From: Jon-Eric White
Sent: Wednesday, November 20, 2019 2:12 PM
To: Katelyn E. Sullivan
Cc: Anthony Furnari; Jamie Tuccolo; Diane Gagnon; David Shaw; Julia Godtfredsen; Phil Christiansen; Andrew Port
Subject: RE: 3 Boston Way Smart Growth District Plan and request for comment

Please note that a Smart Growth District (SGD) Plan Approval Application has been received for a new five-story residential building to be located at 3 Boston Way. The applicant is proposing 84 rental units (21 affordable) with both surface and garage parking.

sheet title:
GRADING & DRAINAGE PLAN

project name:
3 BOSTON WAY
3 BOSTON WAY
NEWBURYPORT, MA

C-3

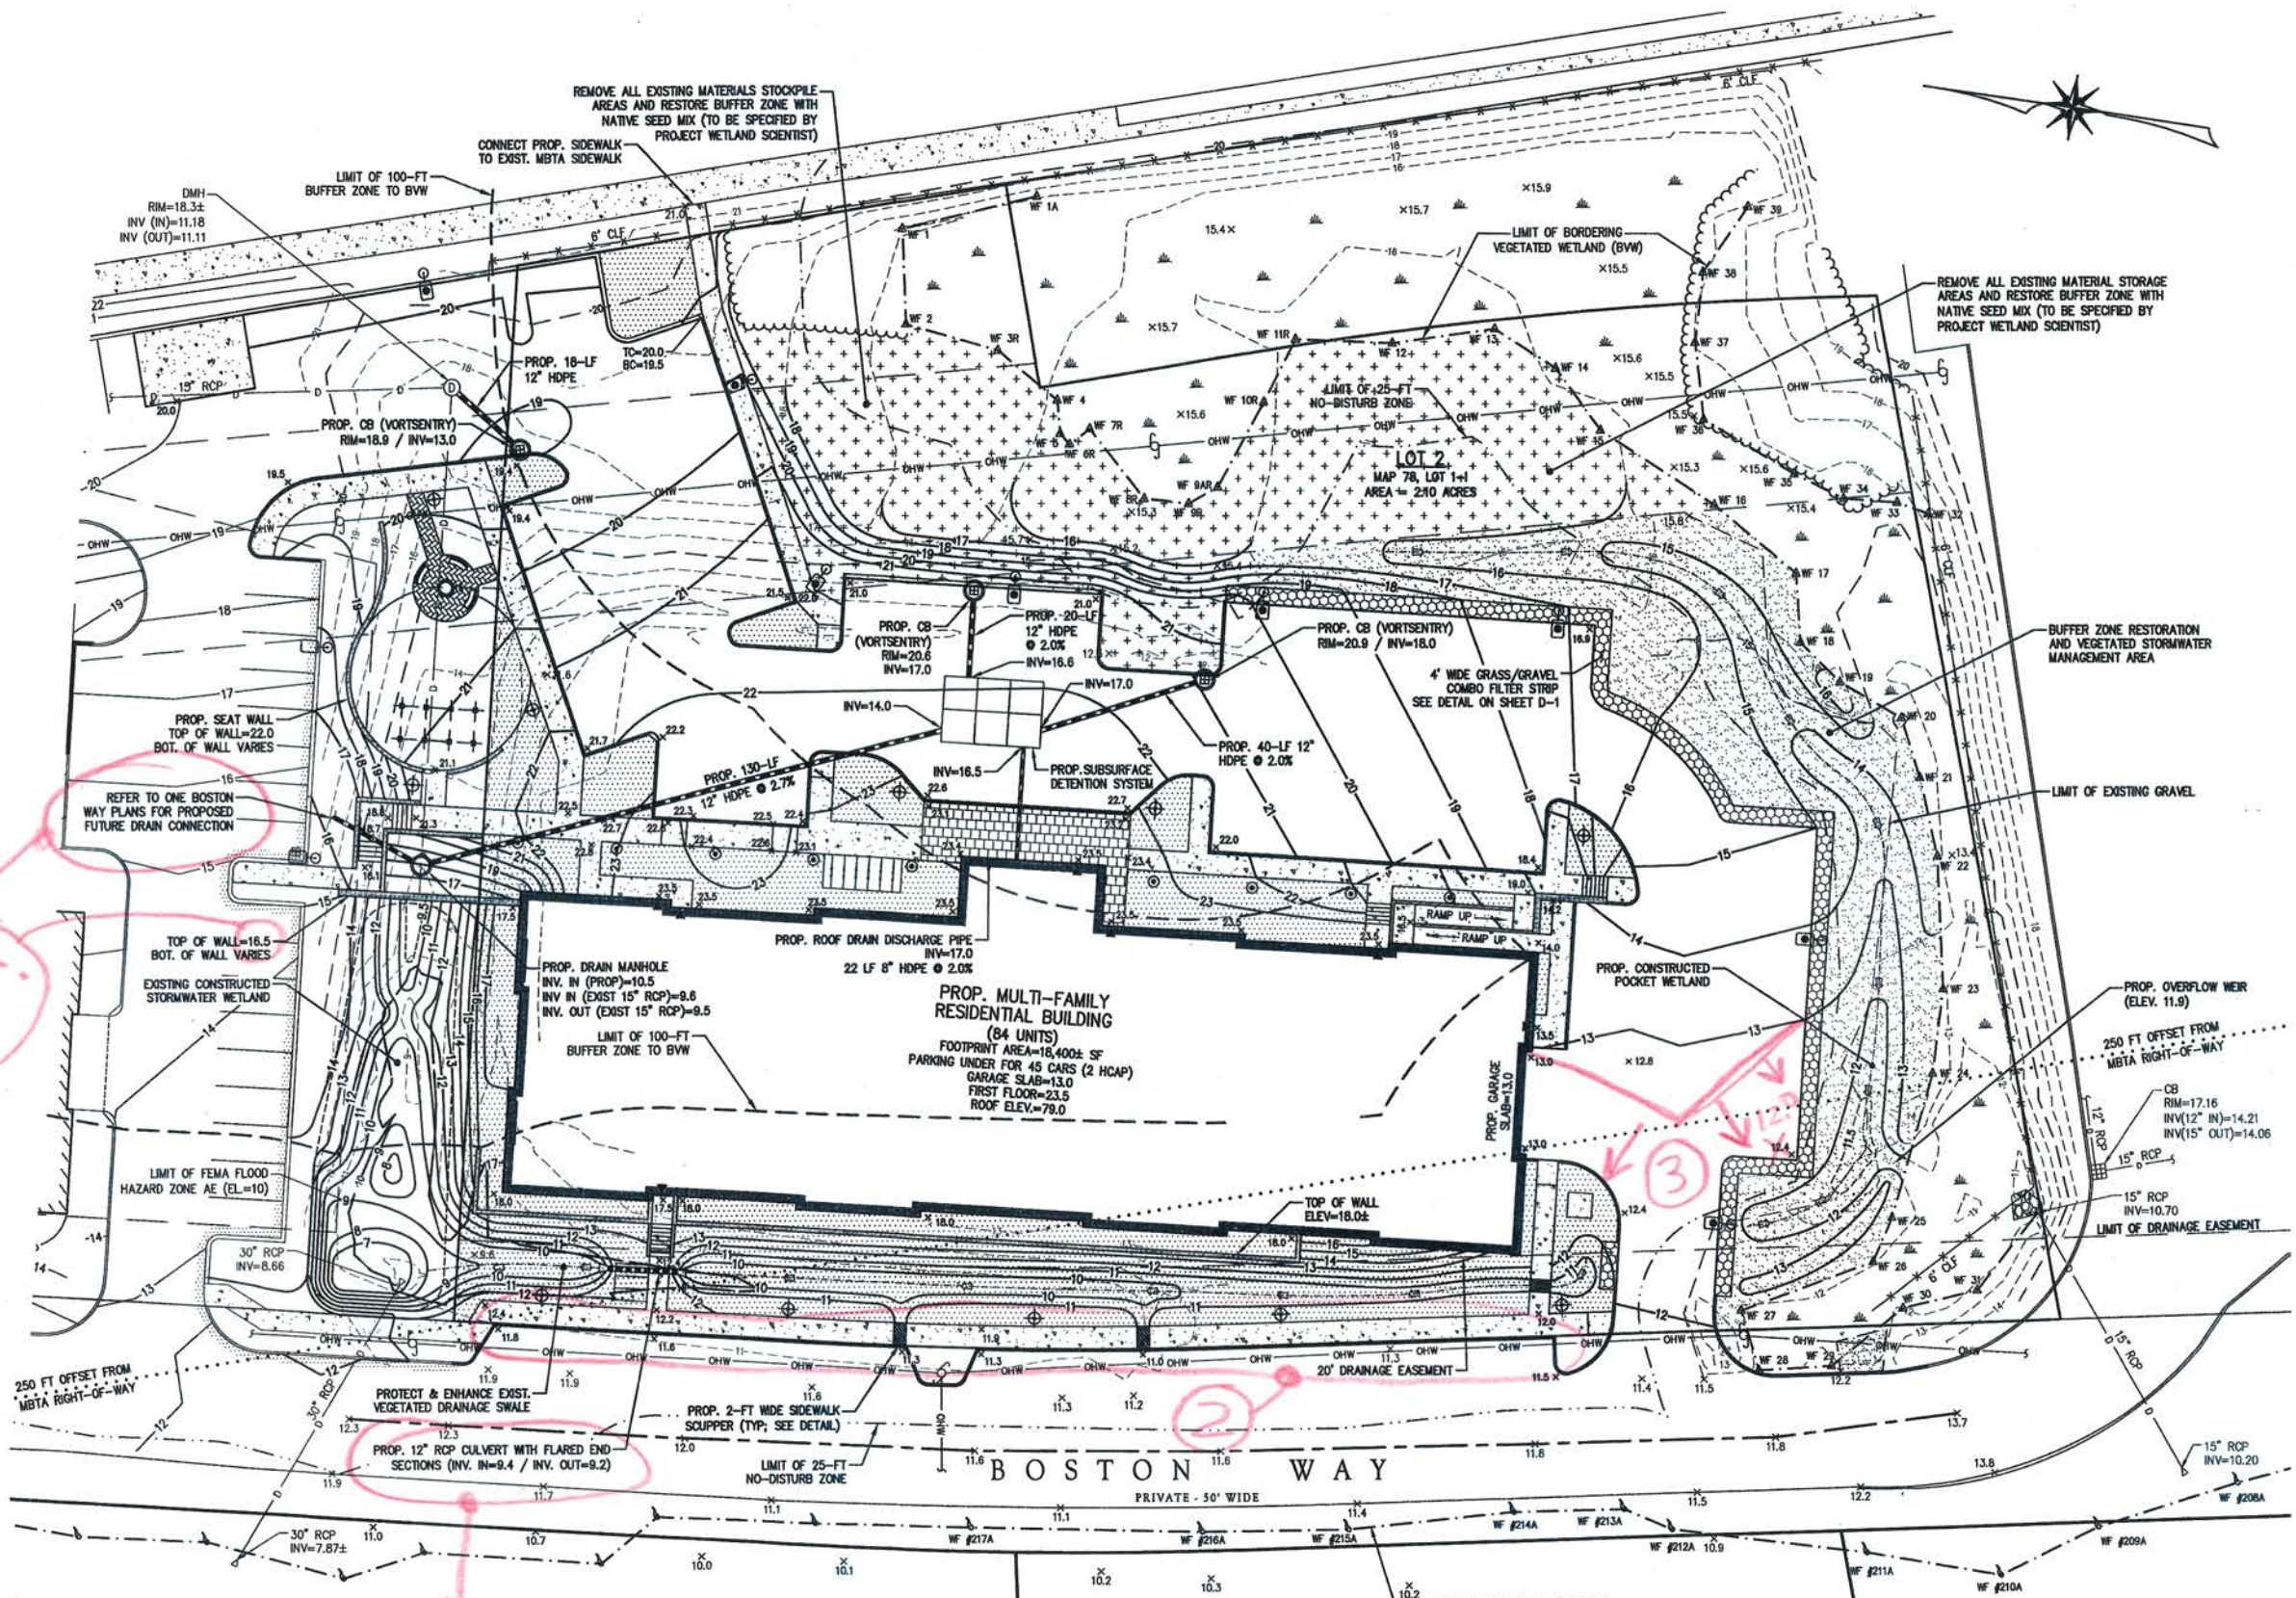
1. Increase the diameter of the pipe connecting the open swales along the west side of the building. This swale system is picking up roadway runoff, which has yet to be included in the drain calcs, which will result in a larger pipe diameter. More importantly, this swale is extremely flat and is very shallow, so it will move water slow and will very likely freeze and clog during the winter, etc. I suggest oversizing the pipe and/or adding a 2nd pipe help prevent runoff from backing up into the road and ponding. The walkway may need to be raised or the stairs could be moved closer to the road to accommodate a larger diameter.

2. Boston Way currently has a very flat cross slope and may be superelevated in spots. The proposed Boston Way gutter along the proposed sidewalk is at the minimal allowed slope, which is acceptable but makes this entire side of the road susceptible to ponding because the road itself is very flat. The slopes of the scupper inverts should also be increased. If cutting into the road to increase the road's cross slope is not advisable, then the roadway's crown should be raised in order to increase the cross slope, which means repaving the entire road.

OR consider superelevating Boston Way in this section by sawcutting along the roadway centerline, reclaim the eastern half of the road, and raise the proposed gutter and sidewalk a foot or so. We commonly provide new stormwater wetlands or water quality swales to treat runoff from roads without curbing, which could be constructed parallel to the existing road along the wetlands. However, it will eventually merge together anyway with vegetation growth from the existing wetlands so disturbing the area to build a new swale or other BMP may do more harm.

Regardless of whether Boston Way will remain private or become a Public Way, the existing design will likely result in a higher maintenance effort and if maintenance is not done in a timely manner, ponding may result, especially after warmer temps when snow is blocking those scuppers. Which may result in more sand and salt being used, which is not good for the environment.

Options to the current design should be investigated in order to minimize the potential of ponding, icing, and injuries.

3. Suggest to create a more defined cross-slope of the driveway entrance on the south side in order to minimize runoff onto the street. It will also assure flows getting into the stormwater mgt areas and swales.

4. The grading and wall height on north side needs clarification or adjustments. It appears the top of wall should be 17.5. Also, the proposed DMH has a pipe connecting to One Boston Way project but that project does not need to be connected to this, or it's unclear how it's supposed to operate. Will this DMH discharge its' flows thru the proposed wall, and into the swale?

5. Show the manhole covers on the Grading Plan for future reference and O&M purposes.
6. The Applicant shall include an Erosion Control Plan and submit it for our review. This Plan can be used as part of the required Stormwater Pollution Prevention Plan (SWPPP) that the Applicant is required to submit as part of the Notice of Intent to the EPA for a NPDES Construction General Permit. A copy of the SWPPP shall be available on site during construction. Also, the Applicant made aware that prior to construction, they shall file a Stormwater Permit Application with our Engineering Division, which has a fee associated with it.

8. Construction Details:
 - a. Do not install steps inside any manholes.
 - b. If the diamond plate scuppers are approved to be used, then the diamond plate and concrete foundation should extend at least 12 inches more beyond the back of sidewalk. This will prevent someone from inadvertently injuring themselves if they step off the sidewalk (by mistake) at that exact location and fall off the 2-foot drop.
